Addendum Geologic and Soils Engineering Exploration Update  
Response to City of Los Angeles Review Letter  
Proposed Tentative Tract Map # 73957  
Thirteen-Lot Subdivision, Eleven New Residences  
Western Empire Tract (MP 18-162/163 [SHT 4]), Lot 202½ (Arb. 2)  
8100, 8150, and 8160 West McGroarty Street (aka 10000 North McVine Trail)  
Sunland, California

Geology and Soils Report Review Letter, Log # 93472-01, dated December 5, 2017.

This addendum geologic and soils engineering exploration update has been prepared to provide the additional information requested by the LADBS in the Geology and Soils Report Review Letter, dated

REVISED SECTION H-H

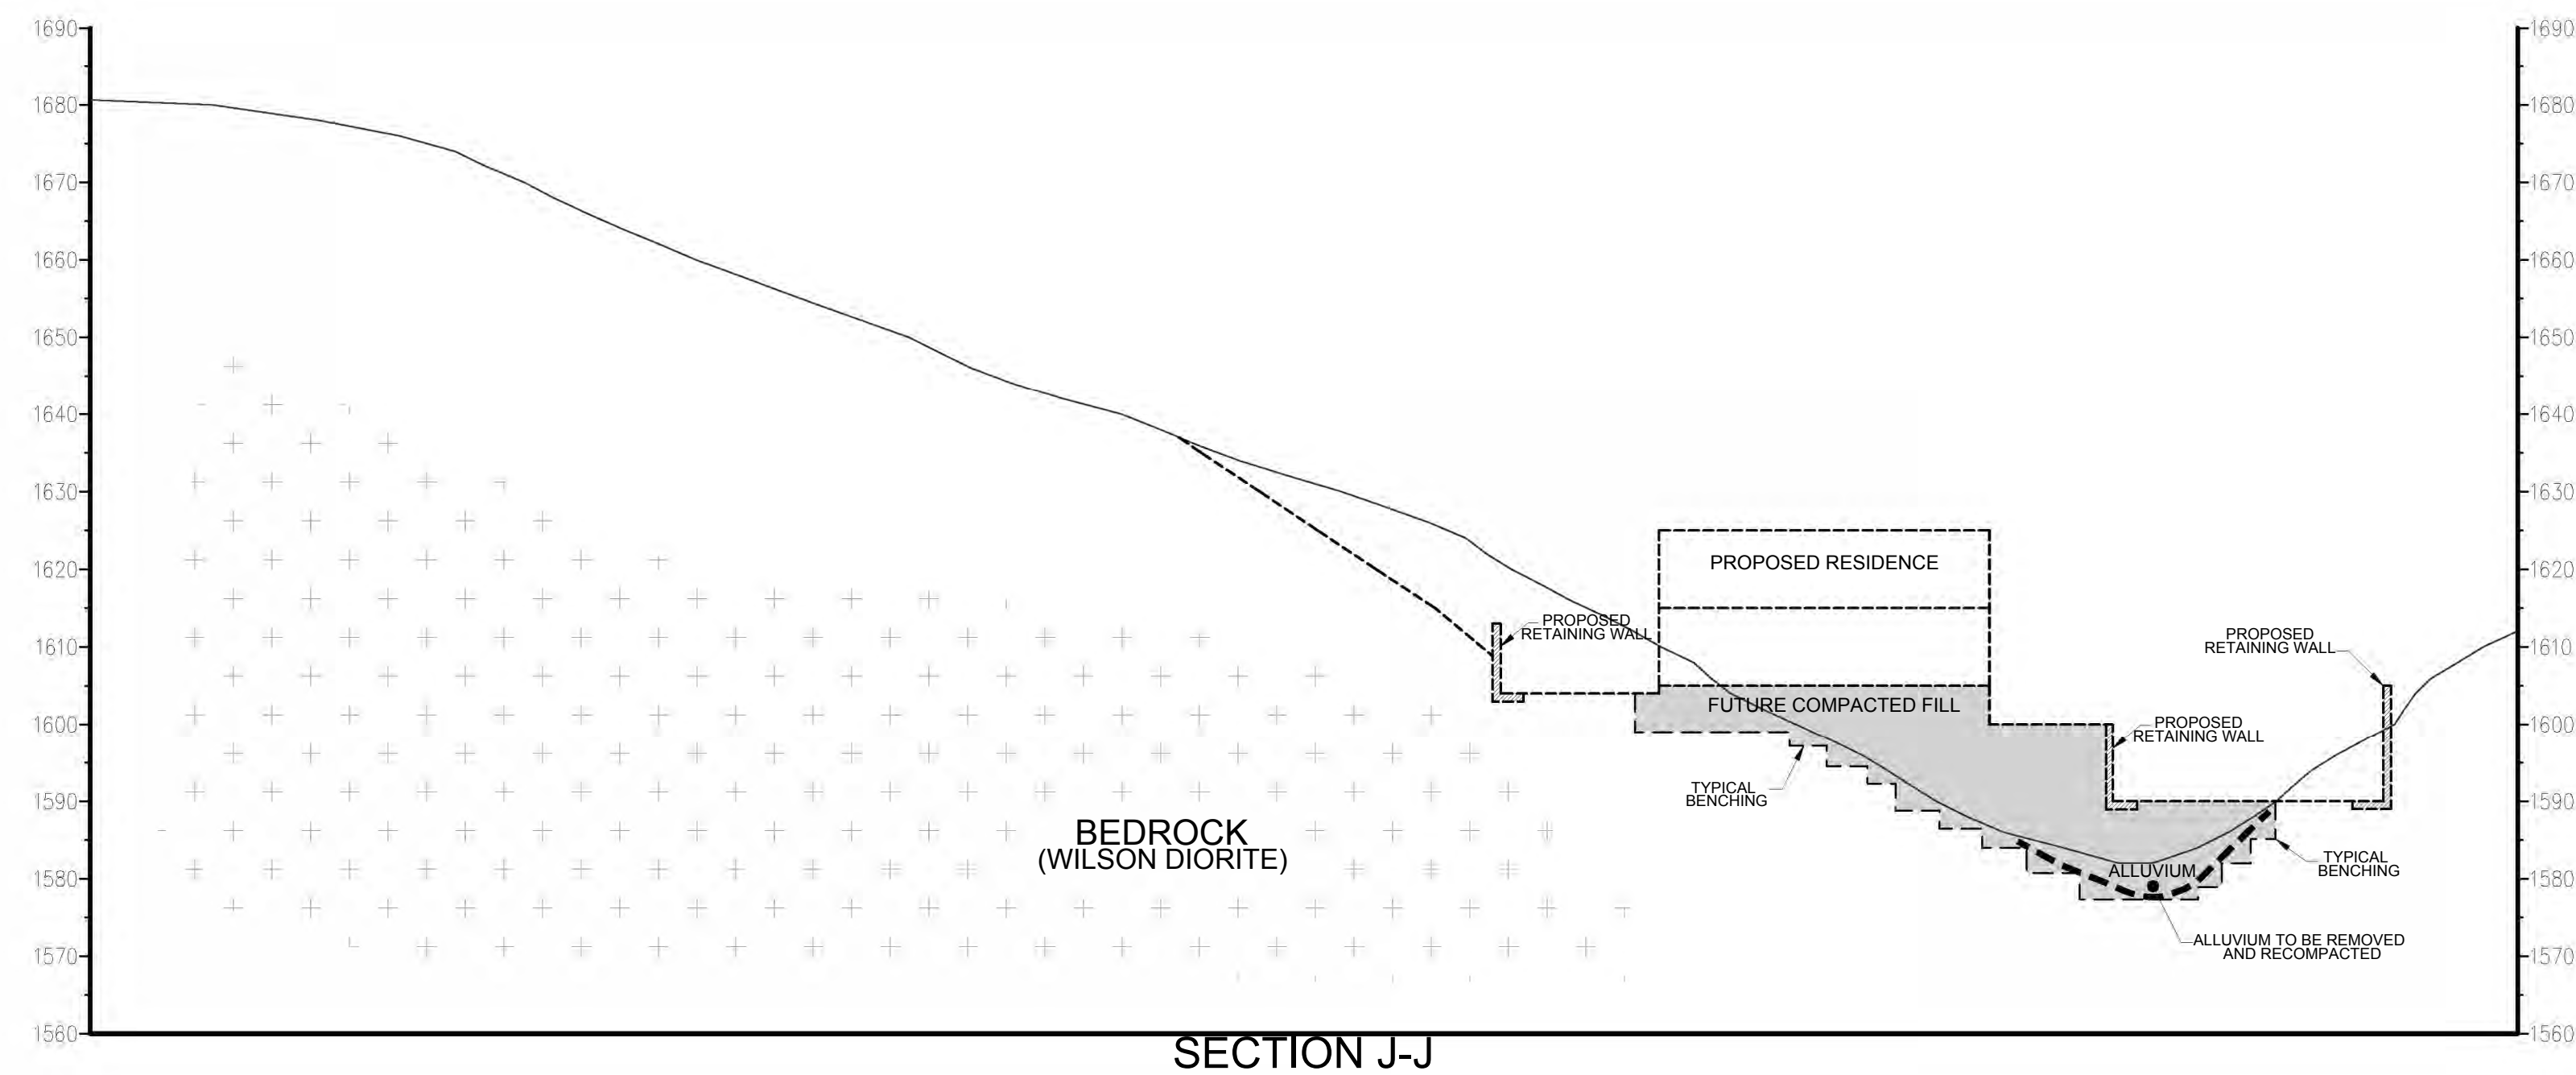
Item 2. *The consultants proposed a 1:1 street cut, offsite cut slopes adjacent to the subject lots are steeper than 1:1 (Sections H and M), and other slopes 1:1 or steeper existing [exist] on the subject lots. As previously requested, for rock slopes 1:1 (H:V) or steeper to remain (native or cut), provide additional geologic mapping and analysis that incorporates, but not limited to, the following:*

Response: The slope depicted in Section H is 1:1 or flatter. The slopes steeper than 1:1 adjacent to the driveway and McGroarty Street (see Sections K and M) have been mapped in detail, and the joint planes mapped are shown on the Revised Geologic Map.
